## **RIVER DISTRICT DESIGN COMMISSION REGULAR MEETING AGENDA**

**January 9, 2025**

DATE: January 9, 2025  
TO: River District Design Commission  
FROM: Renee Burton, Division Director of Planning  
RE: Certificate of Appropriateness application PZ24-00638 filed by Trophy and Sign Center to approve freestanding sign at 424 Memorial Drive (Parcel 21344).

DATE: January 9, 2025  
TO: River District Design Commission  
FROM: Renee Burton, Division Director of Planning  
RE: Certificate of Appropriateness application PZ25-00079 filed by Rory Dowling to construct a hotel at Parcel 01078 (River Street).

**Sign Type C: Qty 1**  
Ground sign, double-sided  
ped wayfinding, aluminum

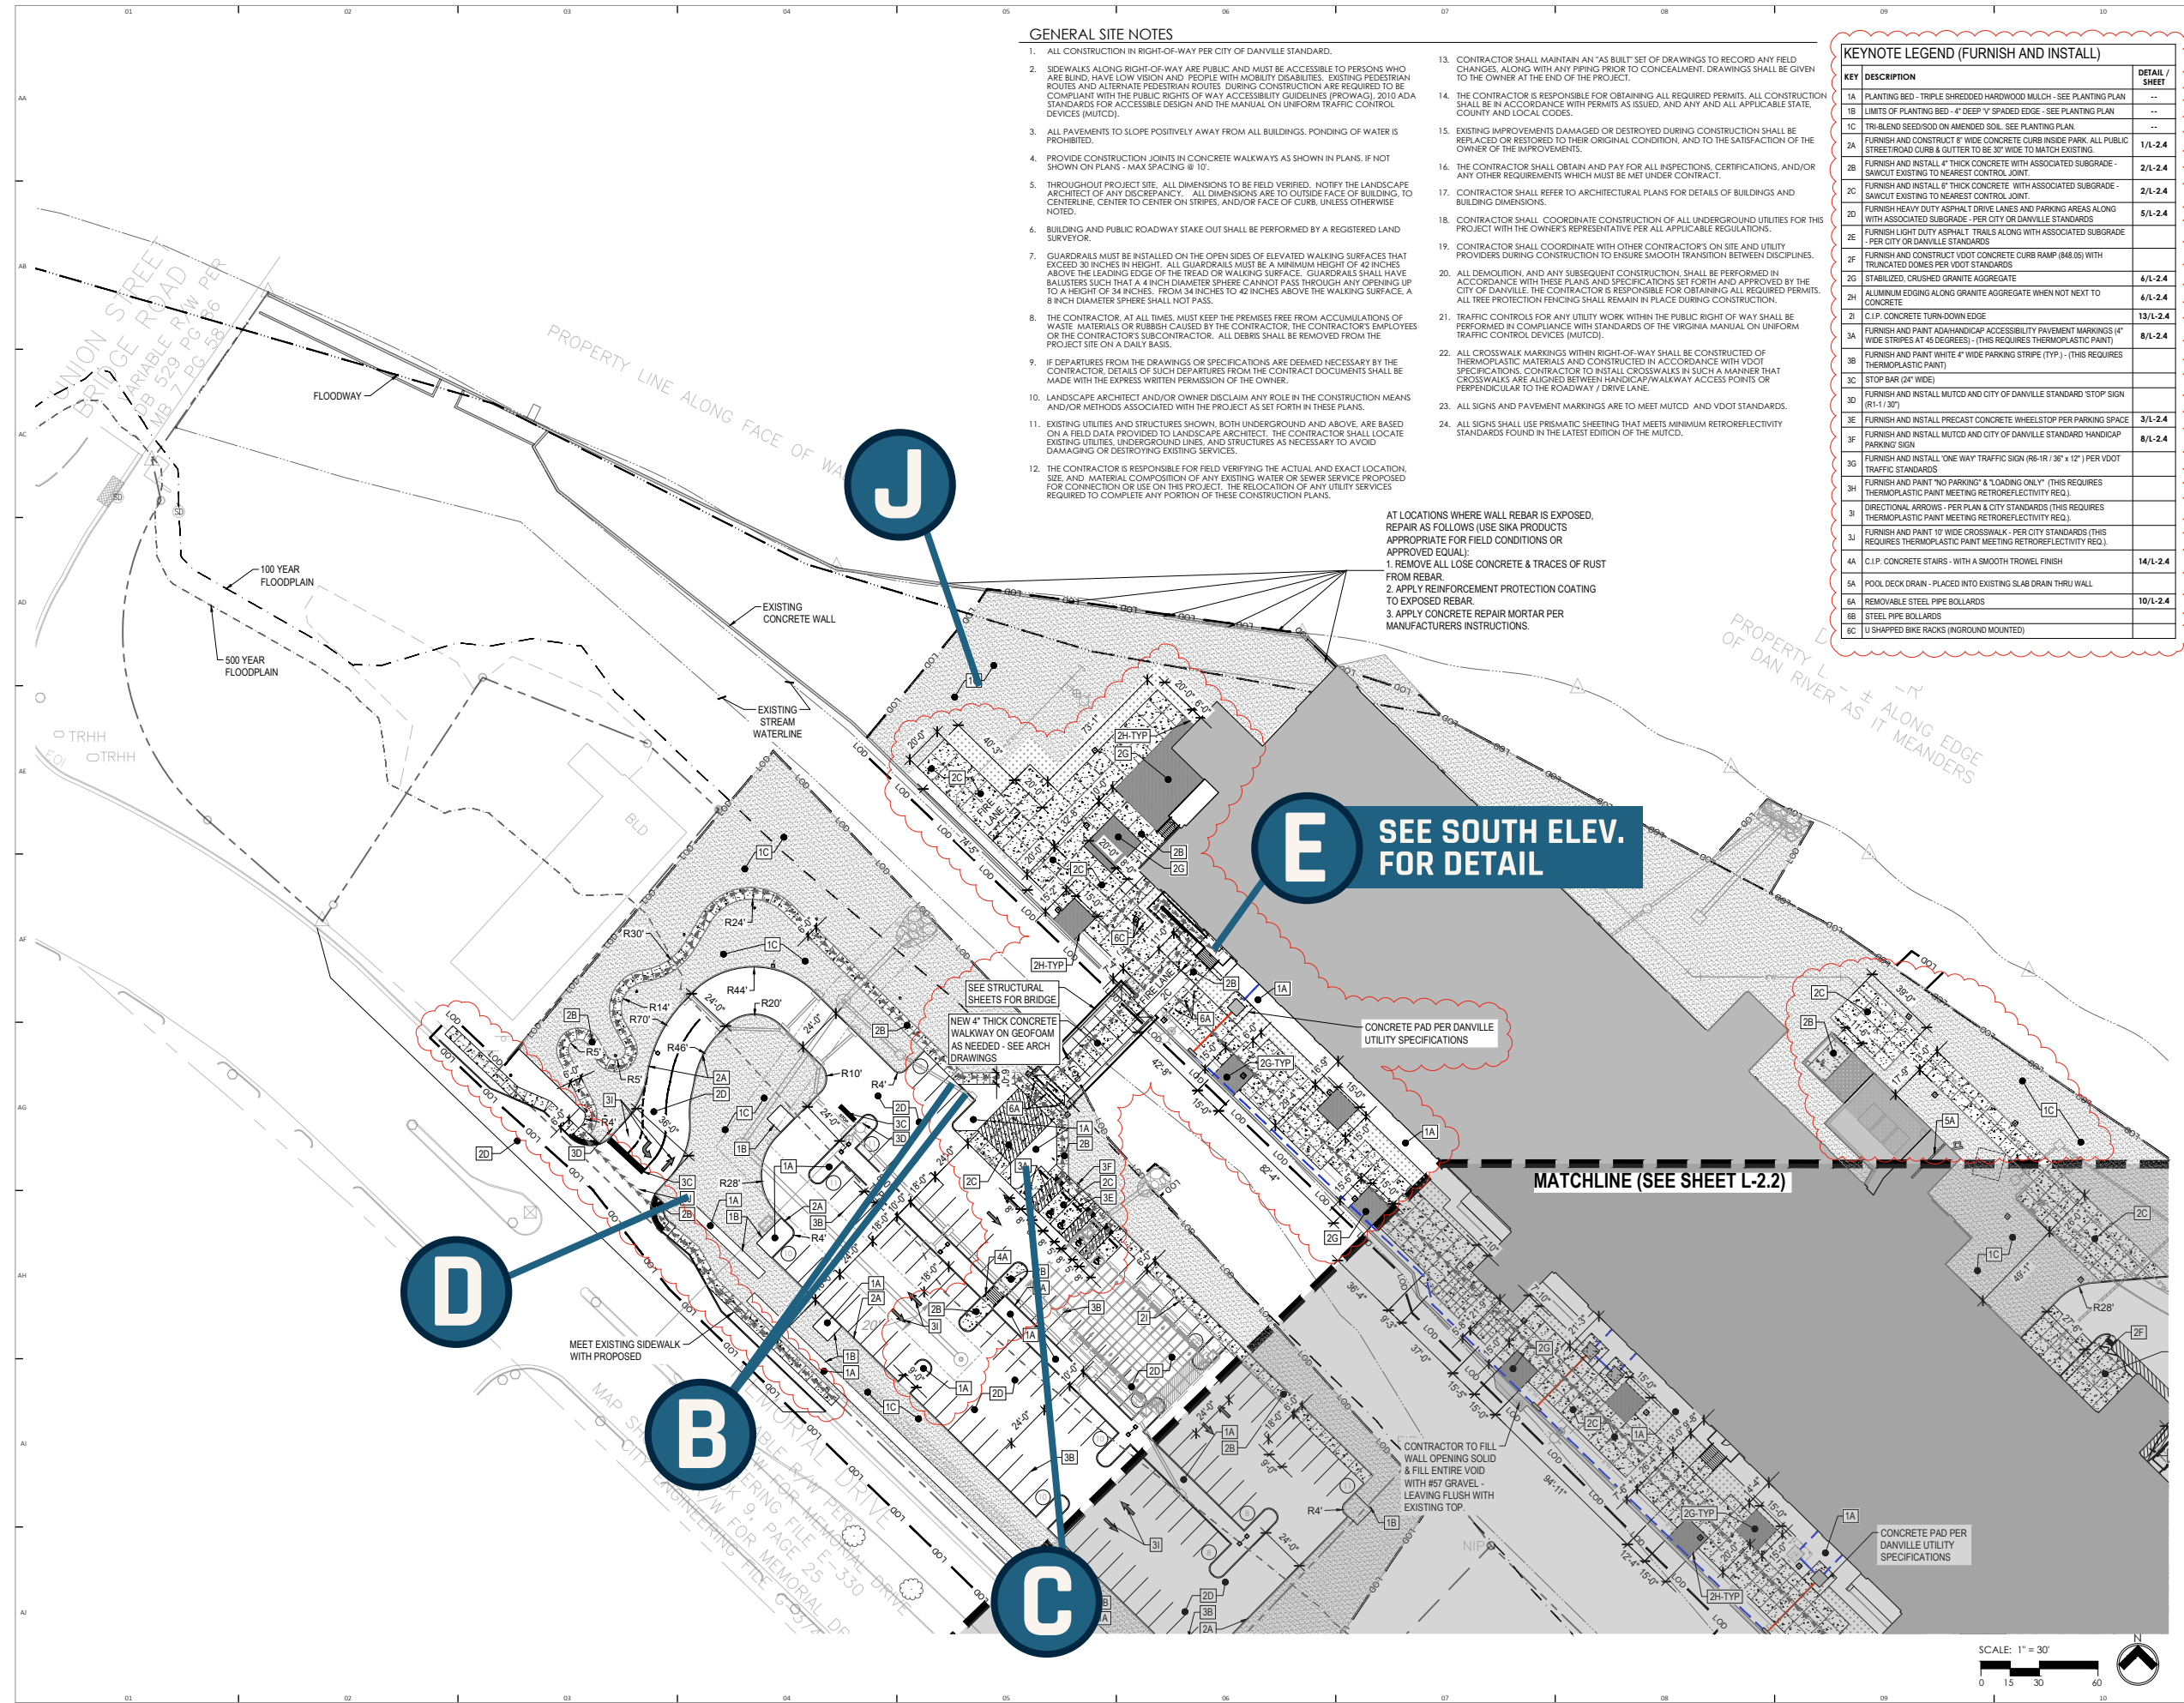
The applicant, Trophy and Sign Center, is requesting a Certificate of Appropriateness for a freestanding sign at the entrance and a directional sign in the parking lot at Dan River Falls. The signs were previously approved by the zoning division and a sign permit was issued prior to realizing that a review by the RDDC was required.

The entrance sign is a 3.5 foot by 4.9 foot monument sign located at the front entrance on Memorial Drive. The directional sign, which is 4 feet by 1 foot, sits further off the road at the entrance to the foot bridge to direct pedestrian traffic.

The Planning Division recommends approval of PZ24-00638 for signs installed at 434 Memorial Drive (Parcel 21344).

**A6 SITE PLAN**  
SCALE: 1/32"=1'-0"

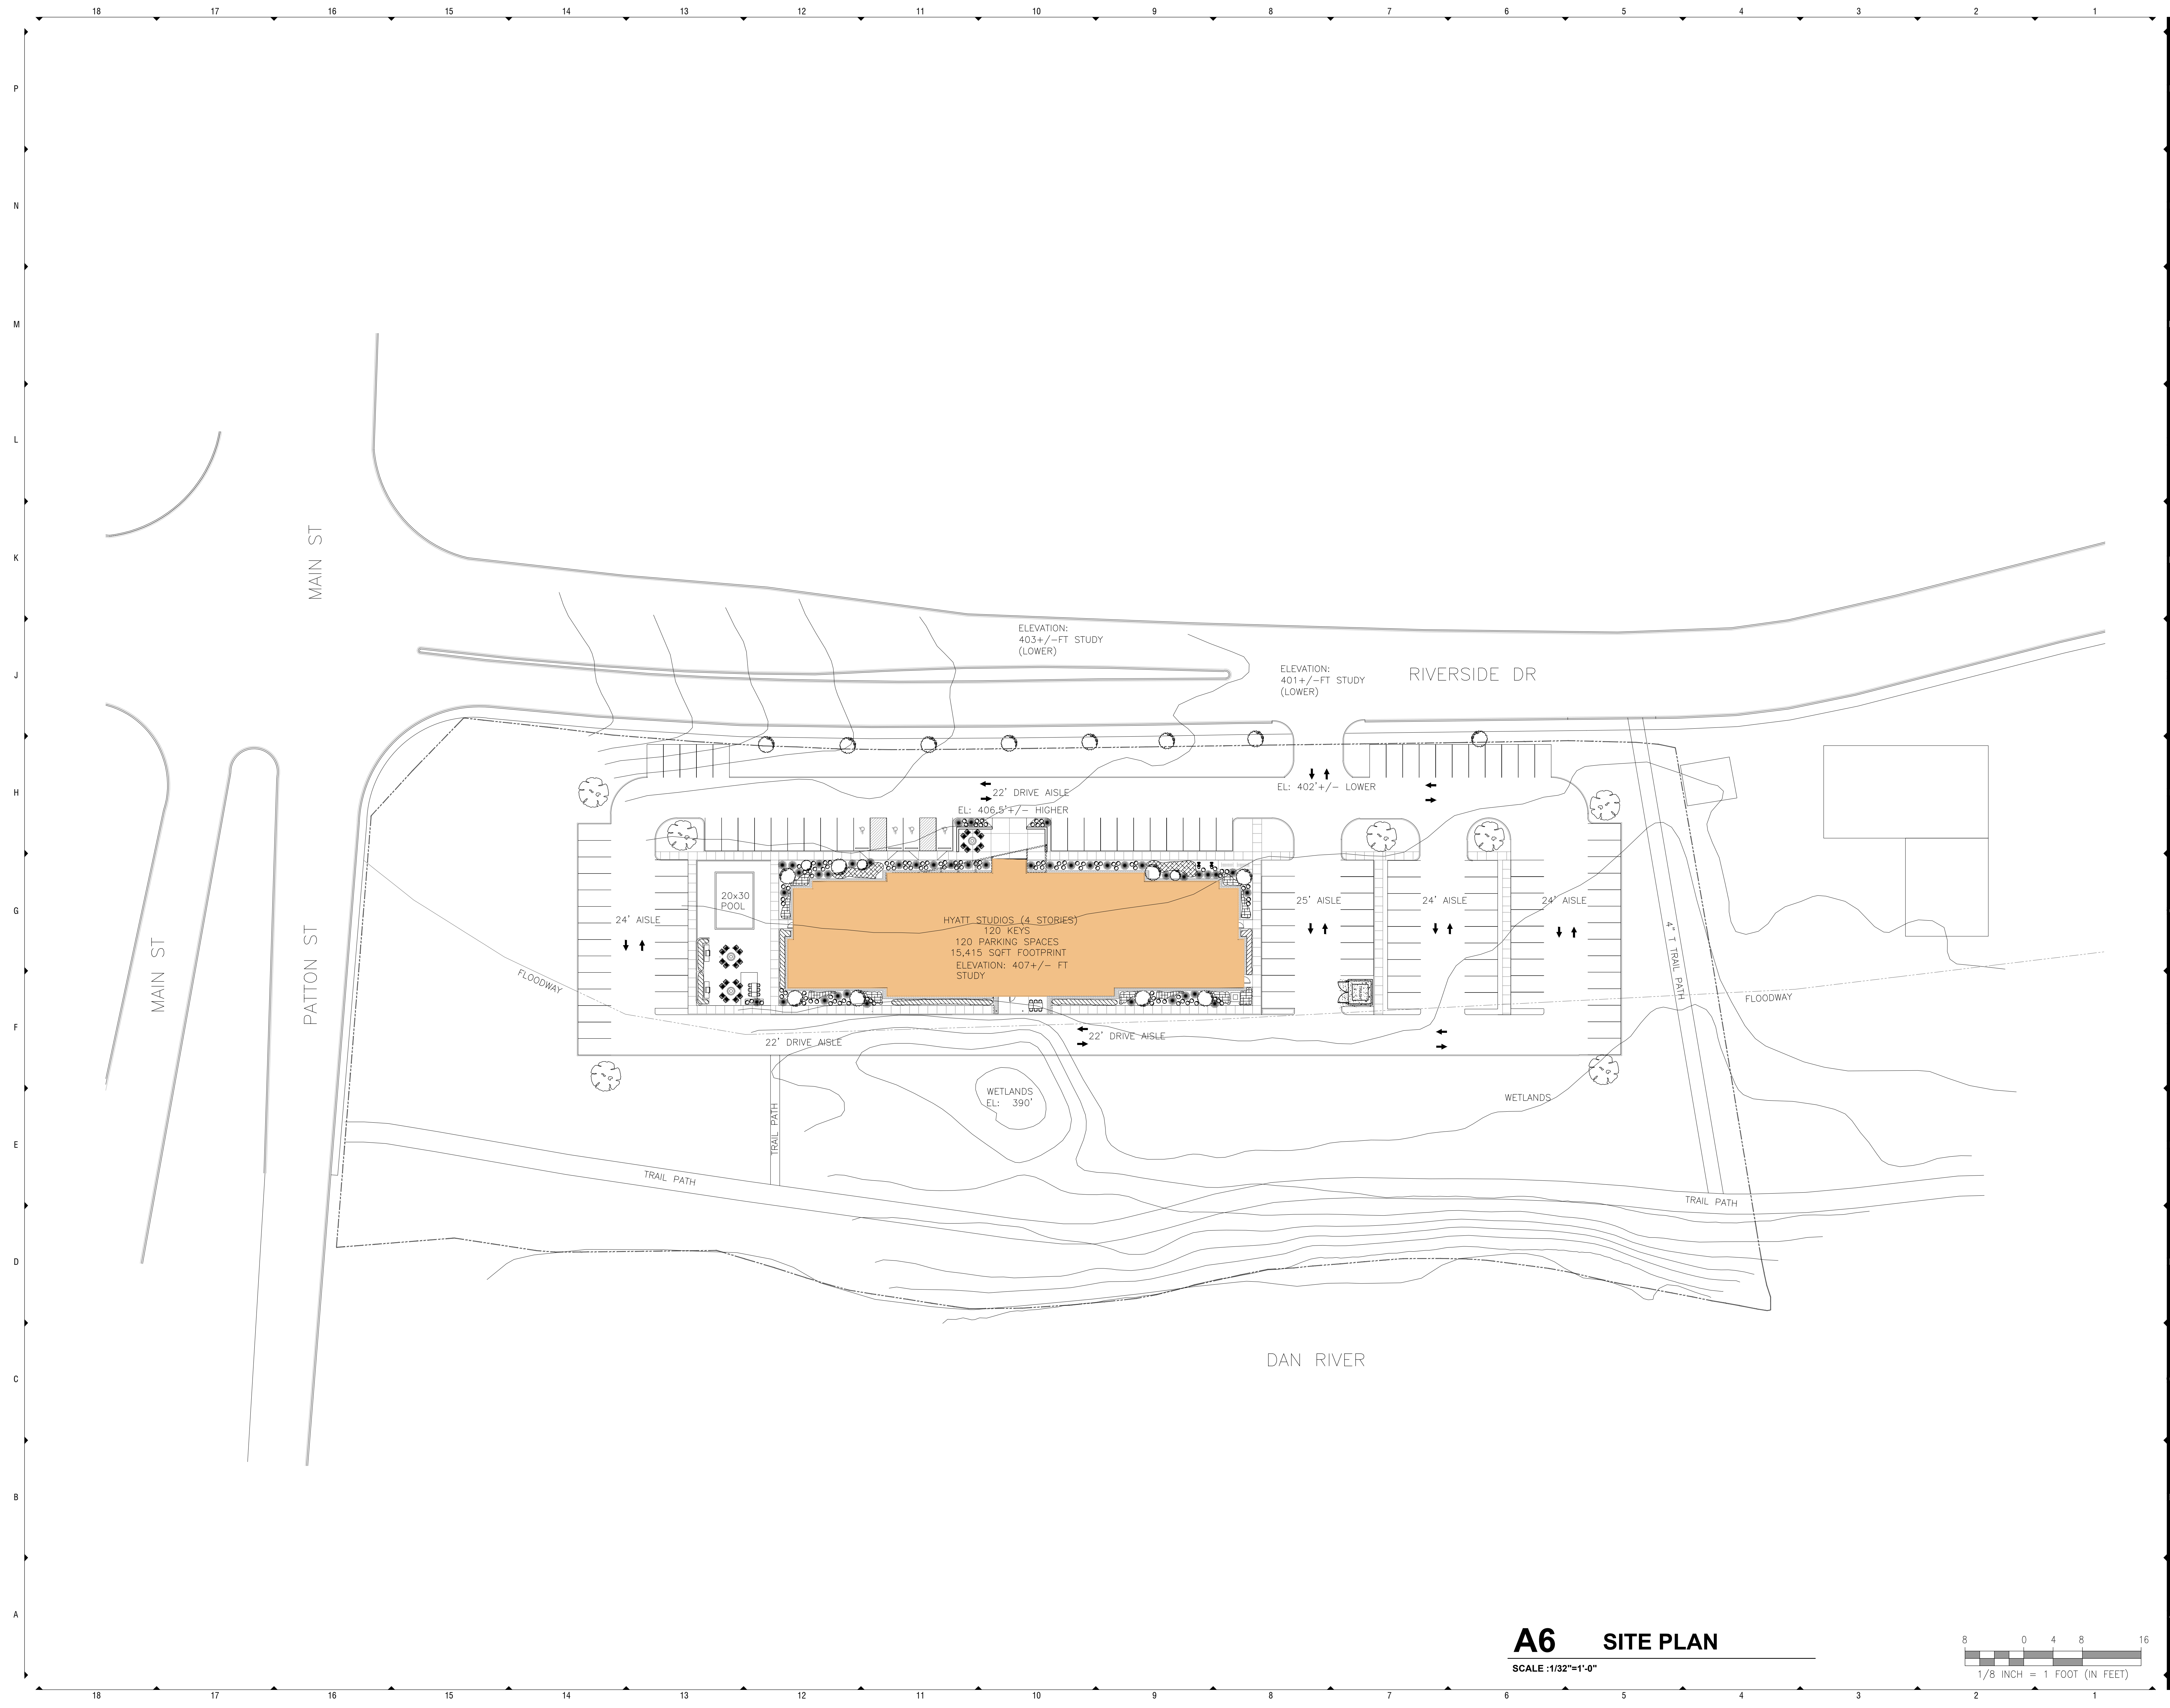
The proposed site plan and architectural design does not meet the guidelines in several areas. Staff recommends the following changes for compliance.

1. Provide a landscape screen between all parking areas and the view from both the road and the river (Chapter 4 Section 3 Item 4).
2. Alter the exterior construction materials so that brick is the predominant exterior material on all sides (Chapter 4 Section 4 Item 3).
3. The window construction must be wood, wood clad in vinyl or prefinished metal, or form aluminum or other appropriate metals (Chapter 4 Section 5 Item 5).
